Addendum No. 1
Page 1 of 2

TO: Prospective Bidders
SUBJECT: Addendum No. 1
PROJECT NAME: **Parking Lot Improvements**
JJC PROJECT NO.: B25018

T-Building – Base Bid

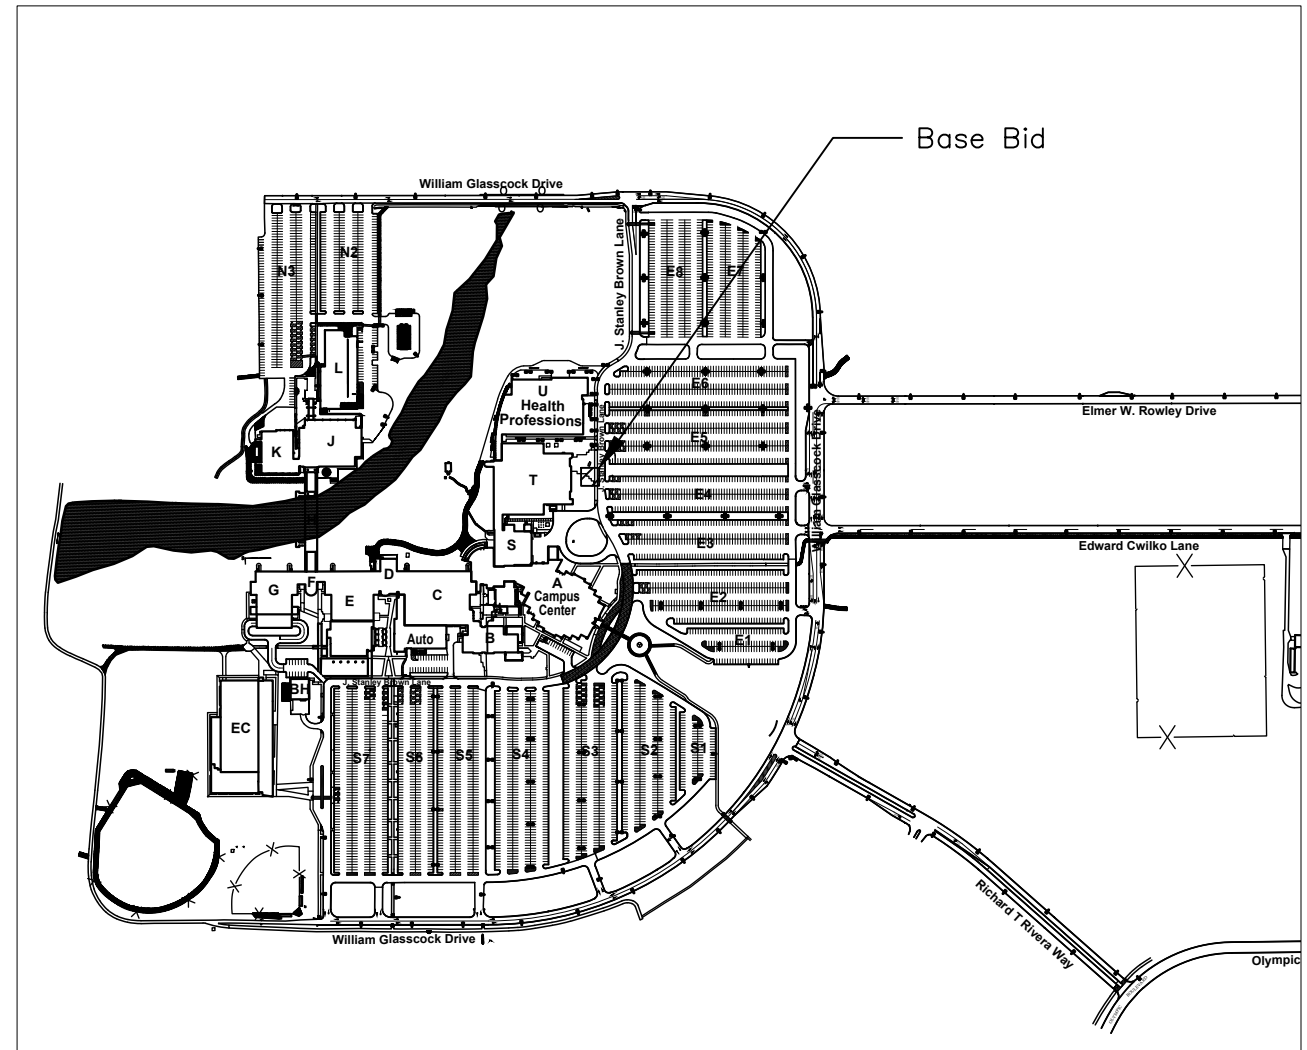
- A. Please refer to B25018 Sketch A1 for concrete repair near the entrance of T building. This work is to be included in the base bid.
- B. Please refer to B25018 Sketch A2 for additional replacement of pavement at entrance road near Houbolt Rd.

1. ADD TO BASE BID – T-BUILDING SIDEWALK REPLACEMENT
 - CONCRETE PAD:
 - REMOVE ANY LANDSCAPING MATERIAL AND TREES/ROOTS FROM SITE AS NEEDED.
 - CONCRETE TO BE 5" THICK CONCRETE WITH #10-6" X 6" WIRE MESH OR FIBERGLASS FILL CONCRETE.
 - INSTALL DOWEL RODS TO TIE NEW AND OLD CONCRETE SURFACES.
 - BACK FILL WITH CLEAN TOP SOIL AS NEEDED AND JJC WILL TAKE CARE OF THE LANDSCAPING FOR THIS AREA.

B25018 SKETCH A2
2/21/2025

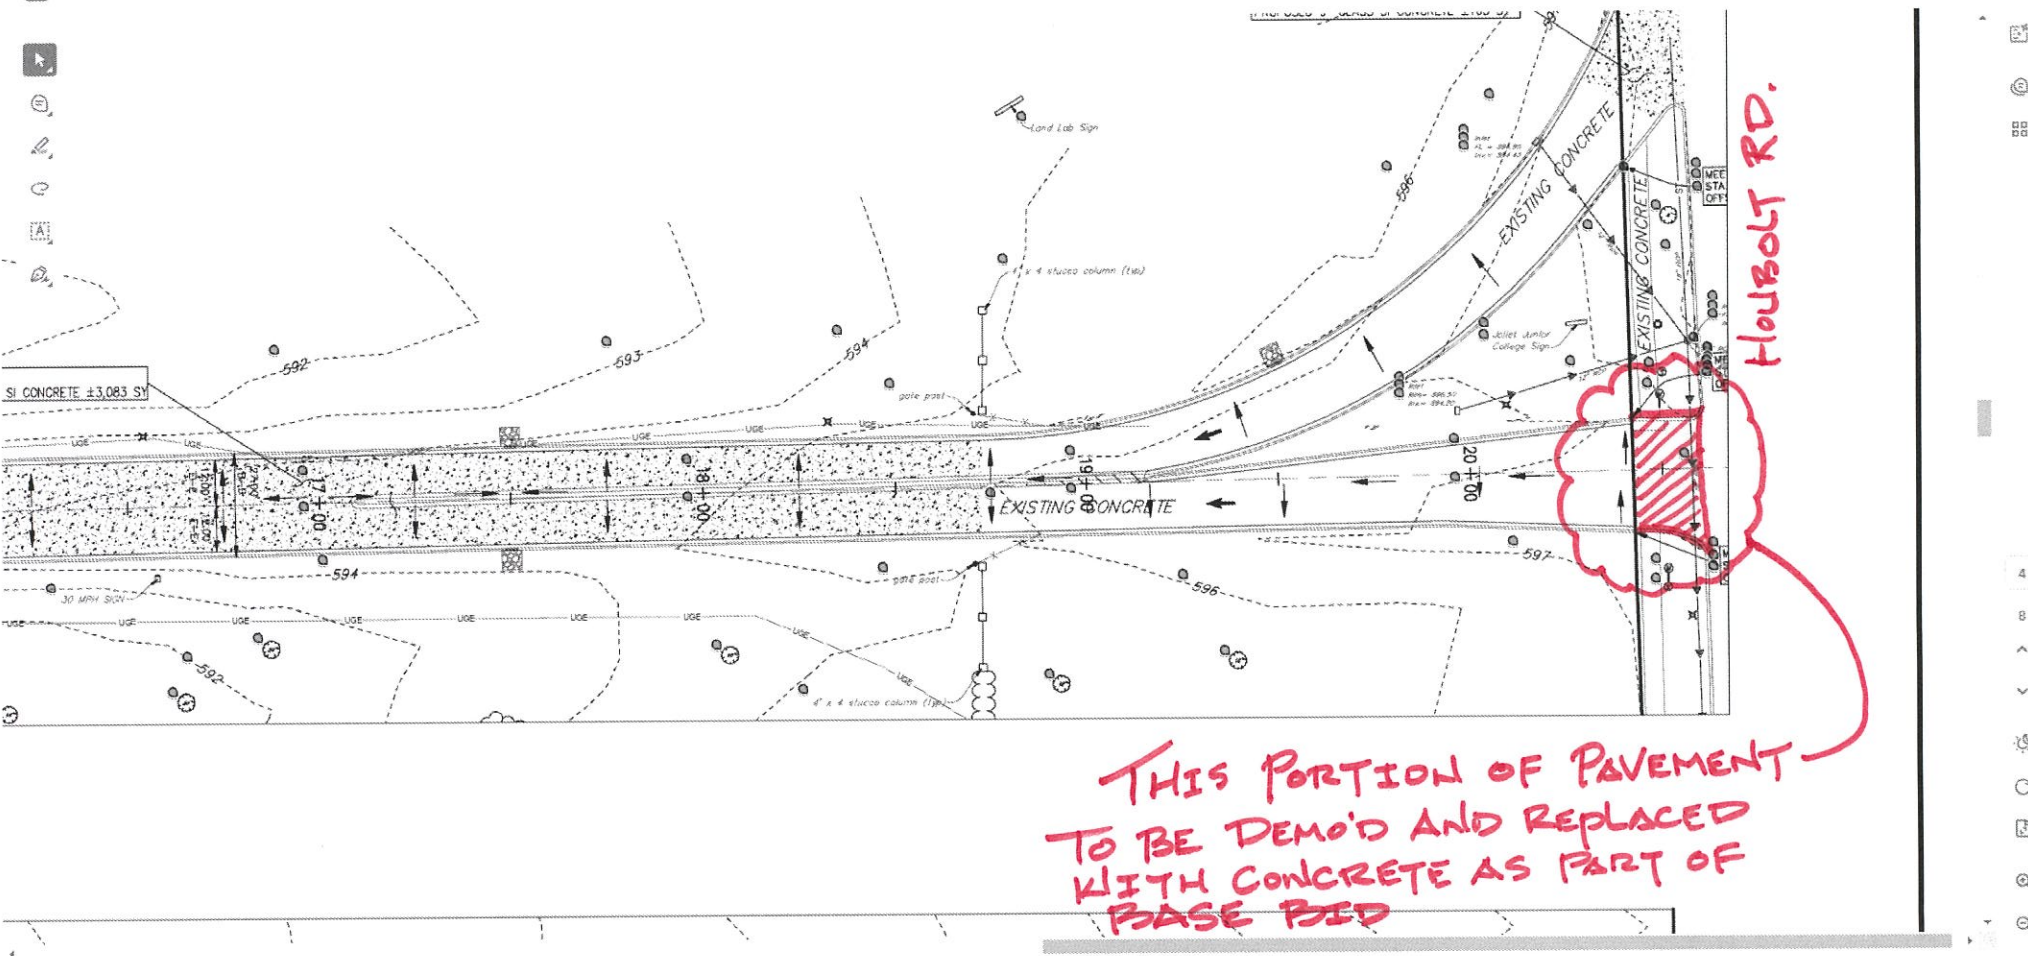
THIS PORTION OF PAVEMENT
TO BE DEMO'D AND REPLACED
WITH CONCRETE AS PART OF
BASE BID
